Underwriters Laboratories Inc.®

SUBJECT: Report of the Meeting of the Ad Hoc Committee of UL for Commercial Refrigerators and Freezers; Request for Comments on Proposed Requirements for the Sixth Edition of the Standard for Wired Cabinets, UL 65; for the Eighth Edition of the Standard for Commercial Refrigerators and Freezers, UL 471; and for the Ninth Edition of the Standard for Fluorescent-Lamp Ballasts, UL 935; PROPOSED EFFECTIVE DATES

PROPOSED REQUIREMENTS AND PROPOSED EFFECTIVE DATE FOR THE NINTH EDITION OF THE STANDARD FOR FLUORESCENT-LAMP BALLASTS, UL 935

PROPOSED REQUIREMENTS FOR THE EIGHTH EDITION OF THE STANDARD FOR COMMERCIAL REFRIGERATORS AND FREEZERS, UL 471

Figure 27A.1
Arcing test set-up

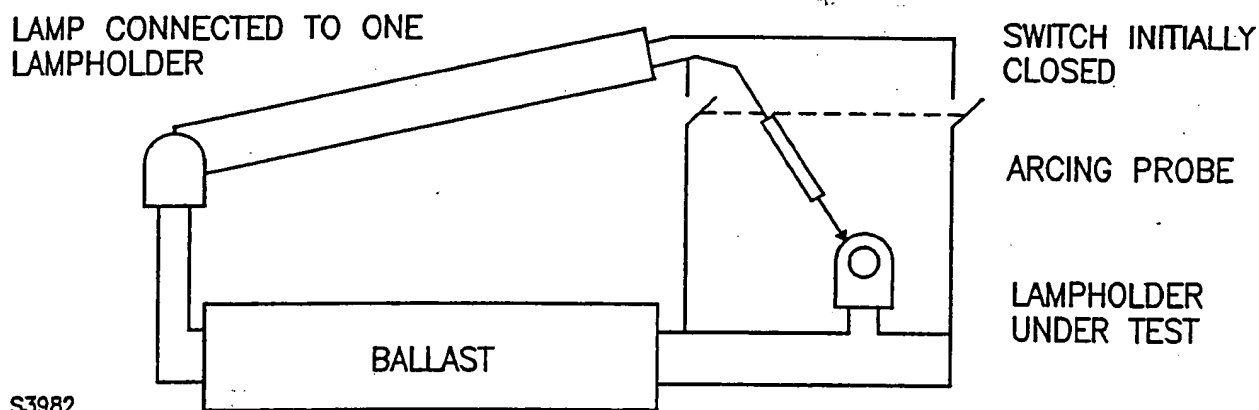
27A.2 The ballast is to be connected as for normal operation except that one lamp is to be disconnected at one end. Additional wiring and a switch are to be added as typically shown in Figure 27A.1. An arcing probe is to be attached at the "free" end of the lamp and the switch, as shown in Figure 27A.1, is to be initially closed. The ballast is to be connected to a source of supply energized at the input voltage and frequency in accordance with 19.7.

27A.3 The lampholder not connected to the lamp is to be wrapped with a single layer of cheesecloth. The arcing probe is to consist of a 1/8 inch (3.2 mm) diameter brass rod sharpened to a point and embedded in an insulating handle.

27A.4 After normal operation is established, the switch shown in Figure 27A.1 is to be opened and an attempt made to create an arcing condition by use of the arcing probe. The arcing probe is to be inserted through the layer of cheesecloth and the attempt to create an arcing condition made by continuing lamp current, and then by drawing back the arcing probe in order to create an arcing condition. The attempt at arcing is to continue for 15 minutes, unless it is obvious in less time what the final result will be.
